Re: SDCI Project 3023260, 7009 Greenwood Avenue N, Type IV Application

Application of 70th & Greenwood Ave, LLC to rezone an approximately 12,188 square foot site located at 7009 Greenwood Avenue North from Neighborhood Commercial 2 with a 40 foot height limit (NC2 40) to Neighborhood Commercial 2 with a ~~65~~ 55 foot height limit and M Mandatory Housing Affordability suffix (~~NC2-65~~ NC2 55 (M)) (Project No. 3023260; Type IV).

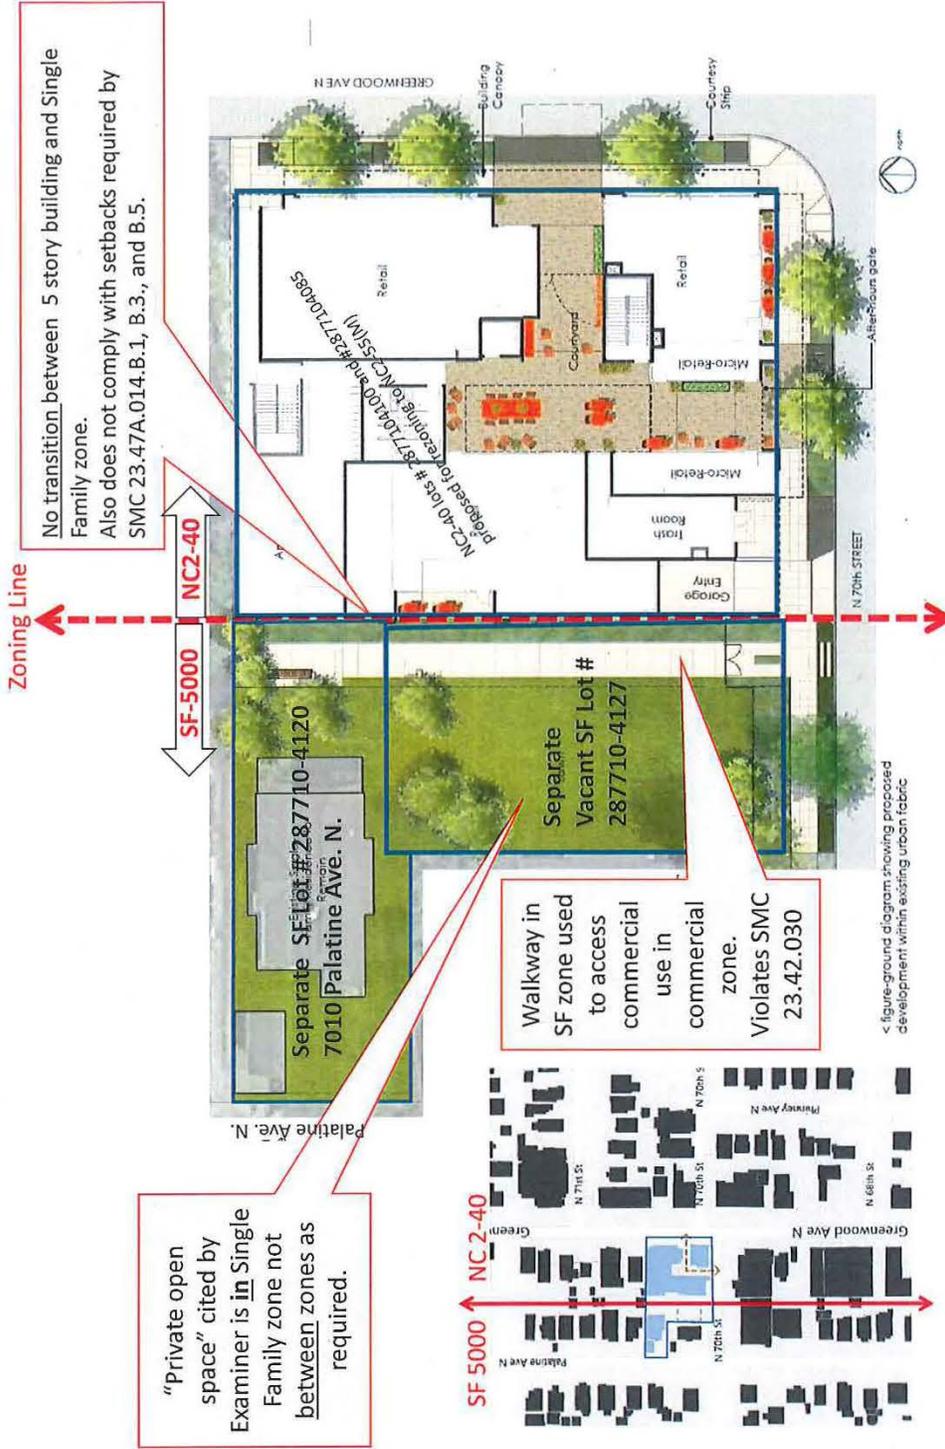
The Examiner counted the vacant lot within the Single Family zone (characterized as “private open space”) as the buffer required between zones.

See Conc. #7 at p8: “A gradual transition between zoning categories would occur between the mid-portion of the project and the SF 5000 zoned properties to the west, as a private open space area will be landscaped to provide some separation between the five story building and the single family zone.”

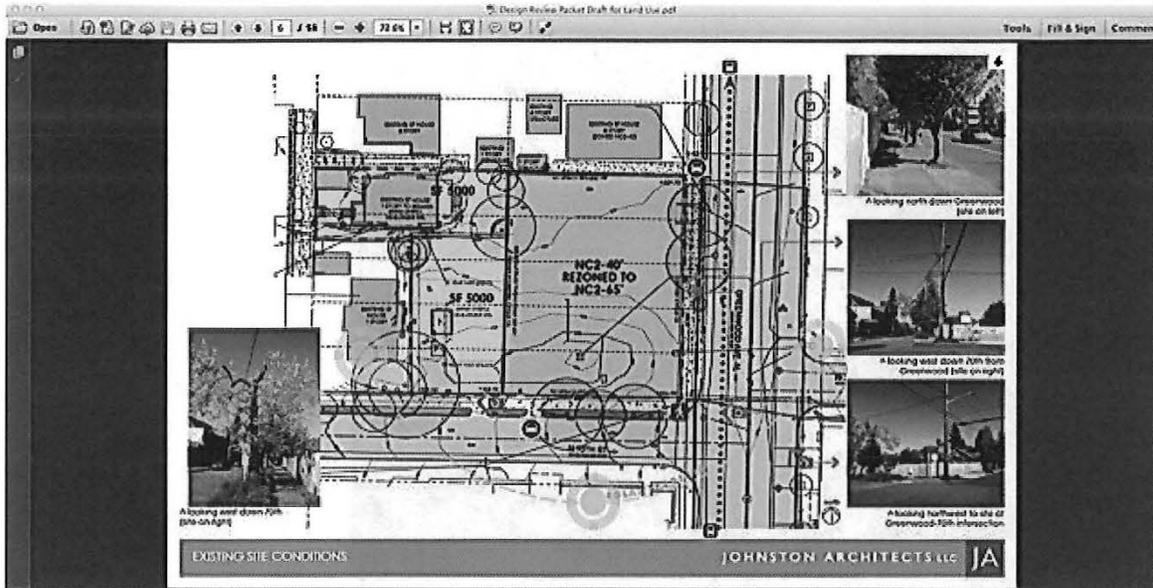
Note also that the zoning / property line follows the same N/S line along the shared rear lines of all parcels on that block. A five story building within the required 15-foot upper level setback on the 7009 parcel steals the light, air, and views of all parcels on that block, and interferes with the view from buildings on surrounding blocks as well.

I hope you will investigate what is really going on here and POSTPONE the forthcoming Design Recommendation meeting until there is a building design that complies with required setbacks. The 12,000 sq foot commercial is already one of the largest commercial parcels in Phinney Ridge. It has ample space to accommodate a thoughtful design without unlawfully encroaching into required setback areas through the creative gimmicks being used here.

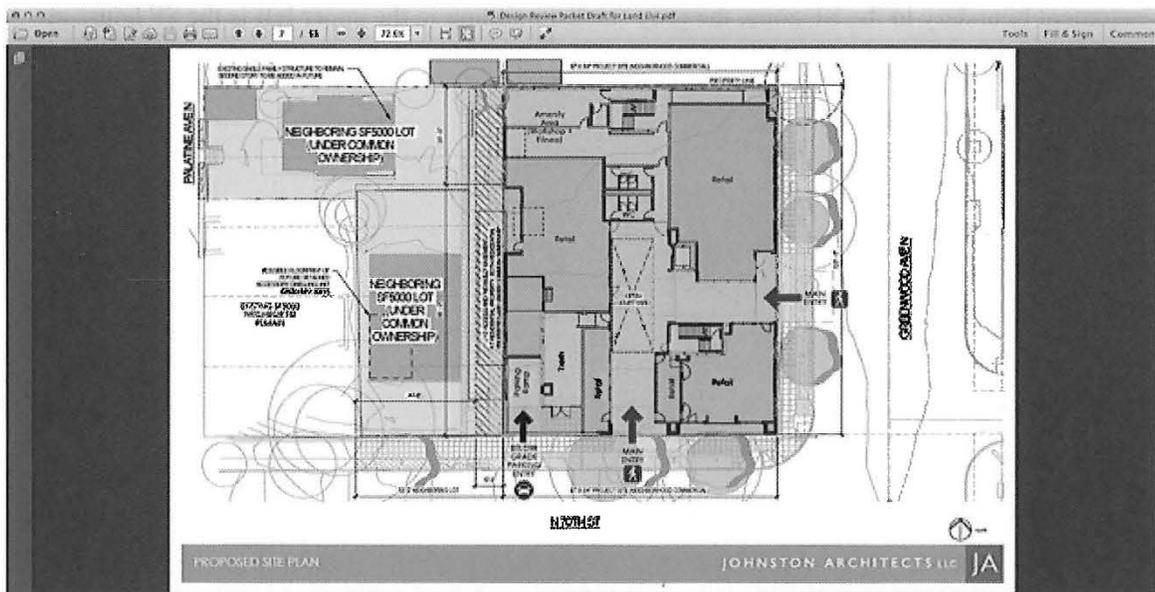
(1) This is the site plan (page 6 of 3.16.17 draft); the property line is the same as the zoning line at the color change separating SF5000 and NC240 zones:

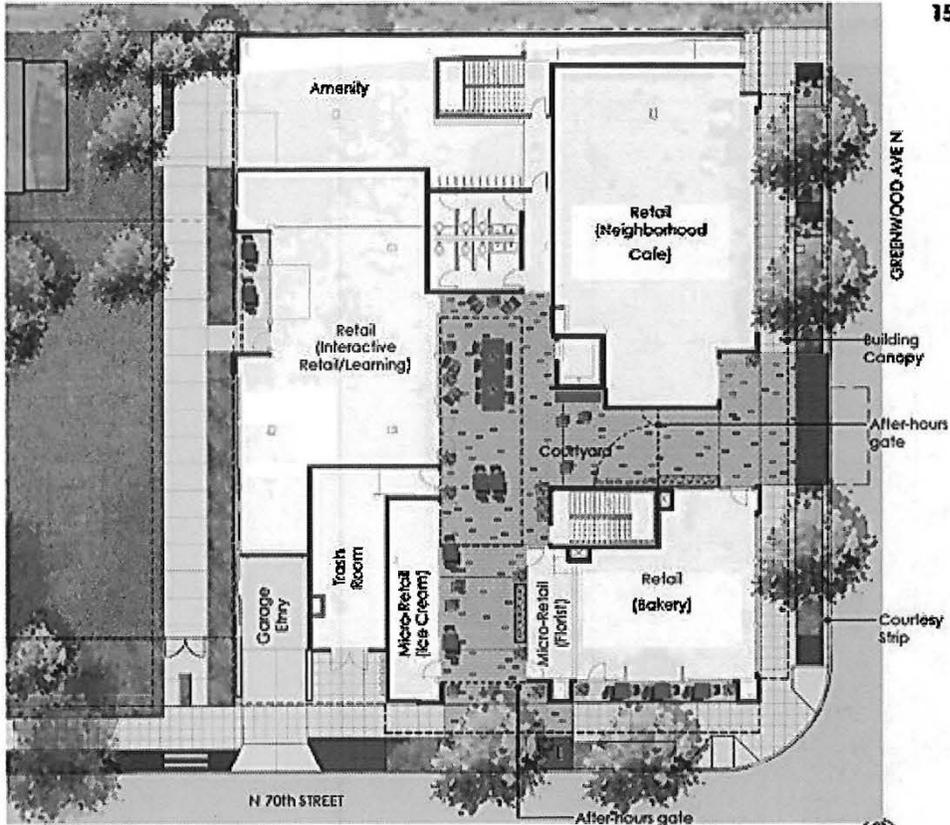
(4) This drawing shows the sidewalk in the easement over the SF5000 zone, accessing the retail space of the commercial building (the property line is at the edge of the building (in white); the dashed line left of the sidewalk is the easement boundary in the SF zone, the grey shaded building in the upper left is the SF house at 7010 Palatine).

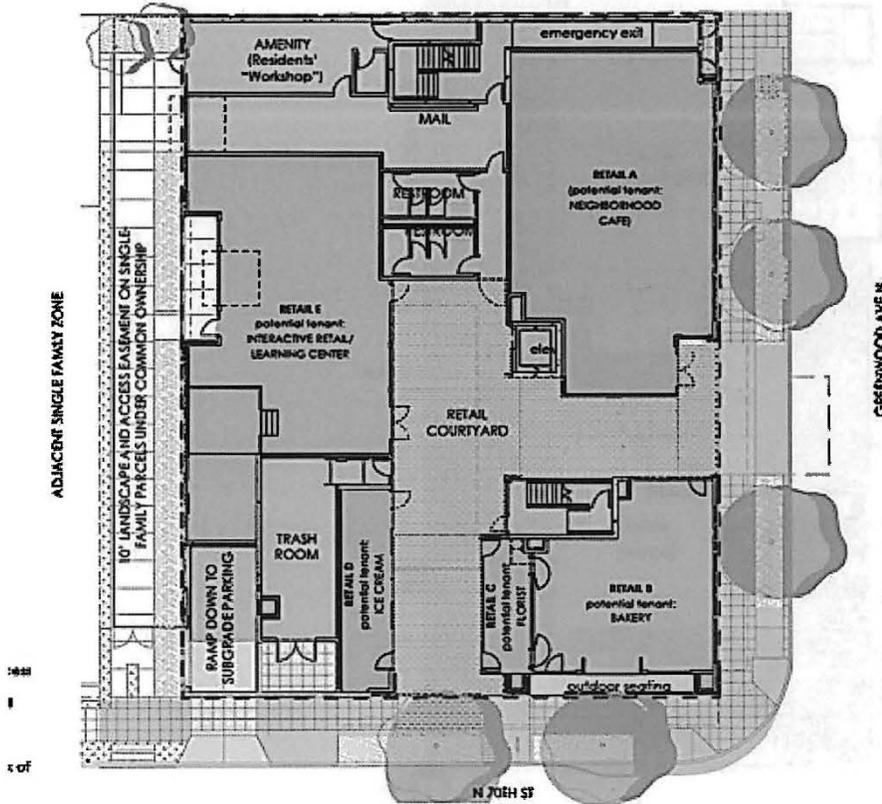
(5) This image describes the drawing above, identifying the easement
